Takoma Junction, Mandatory Referral No. MR2021019, Preliminary Plan No. 120190150, Site Plan No. 820190090

Completed: 09.03.2021

Summary

Figure 3 – Illustrative Site Plan

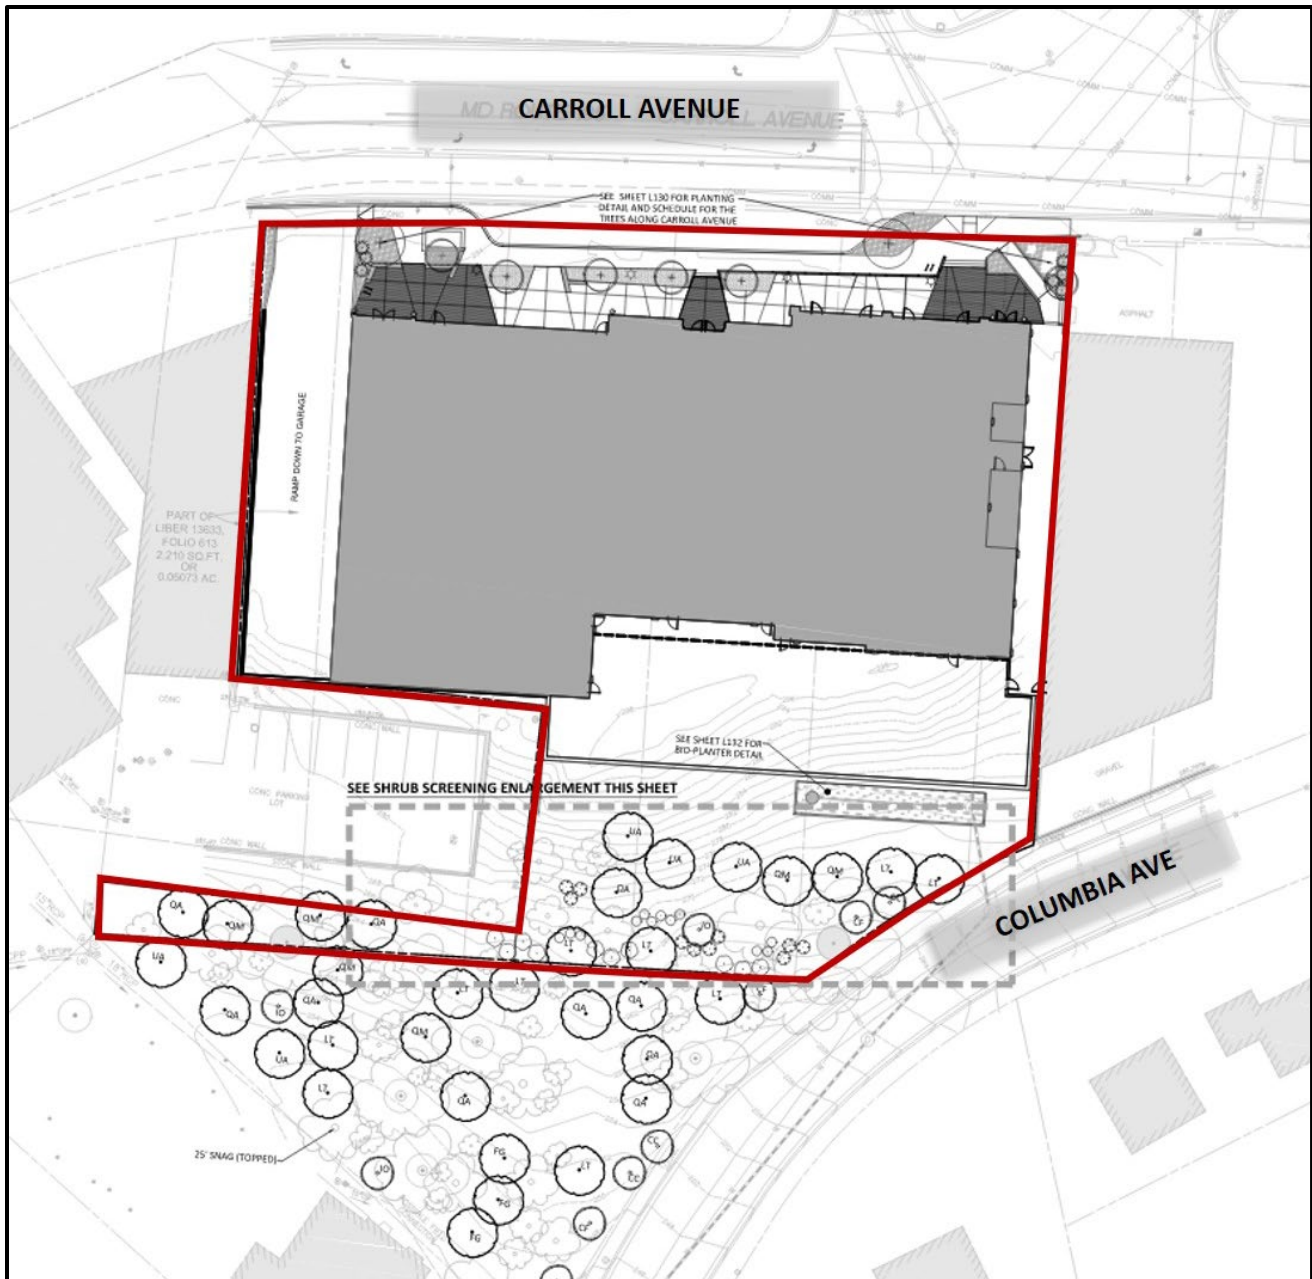
The Applicant proposes to create one lot for a two-story building with up to 40,762 square feet of commercial uses, including restaurant, retail, and office, and below-grade parking. The following Figures show a layby on Carroll Avenue that has not been approved by the State Highway Administration.

Figure 6 – Pedestrian and Vehicular Circulation

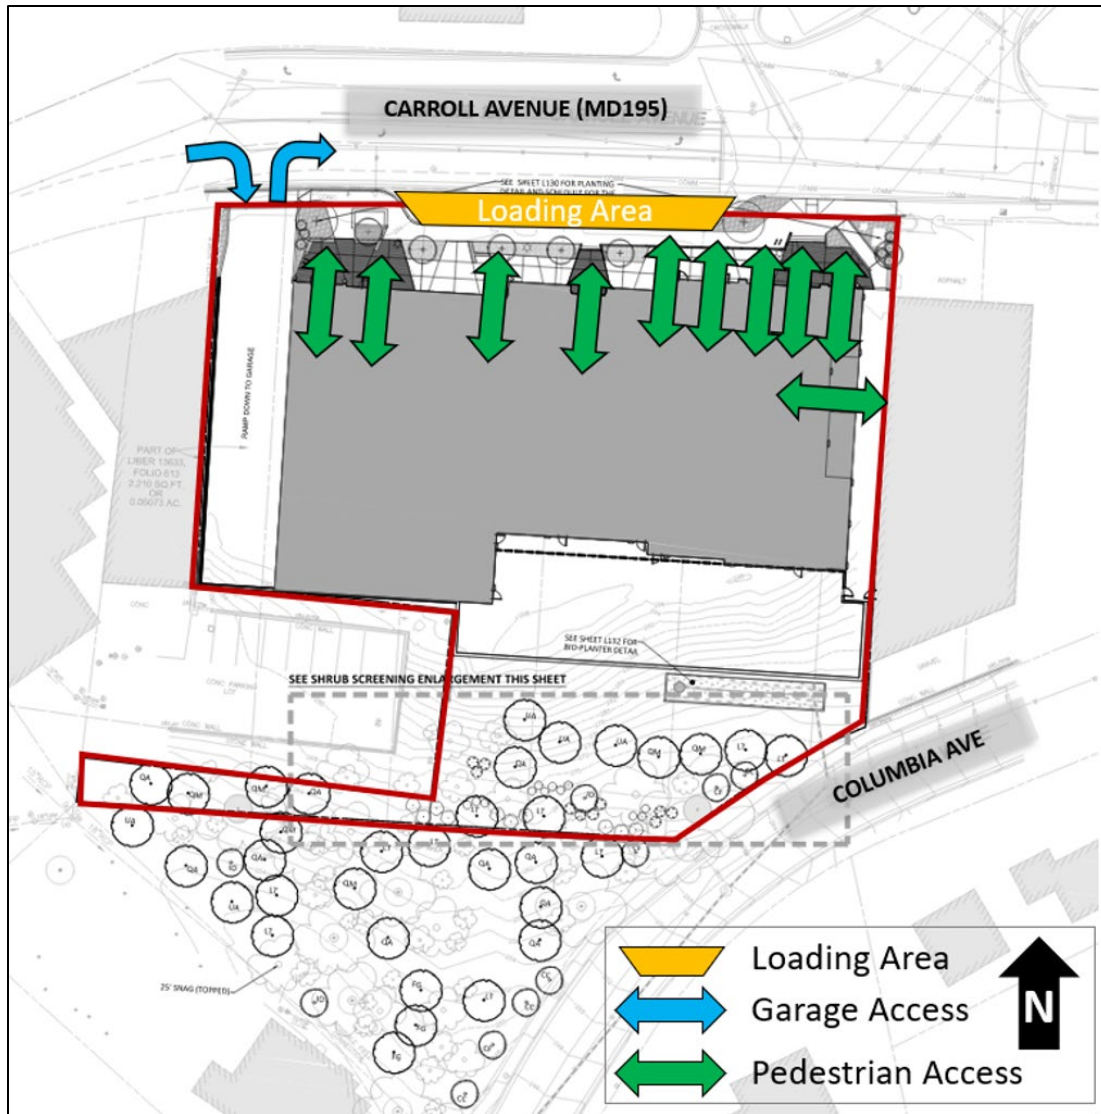
Pedestrian access to the Site is proposed from the established sidewalk network along Carroll Avenue which includes a "Barnes Dance" or "all pedestrian" shared walk signal at the intersection of Carroll Avenue and Ethan Allen Avenue. The Applicant proposes improving the pedestrian pathway to provide a minimum of 6-foot sidewalk along the entire street frontage on Carroll Avenue. In conformance with the 2018 *Bicycle Master Plan* the Applicant proposes to install the master-planned 6-foot bike lanes² on the south side of Carroll Avenue along the Site's frontage.

² As the bike lanes will only be installed along a segment of Carroll Avenue, they will not be marked with the bicycle symbol. Striping will be installed, and the space will be provided. Final pavement striping and marking are subject to MDOT SHA approval.
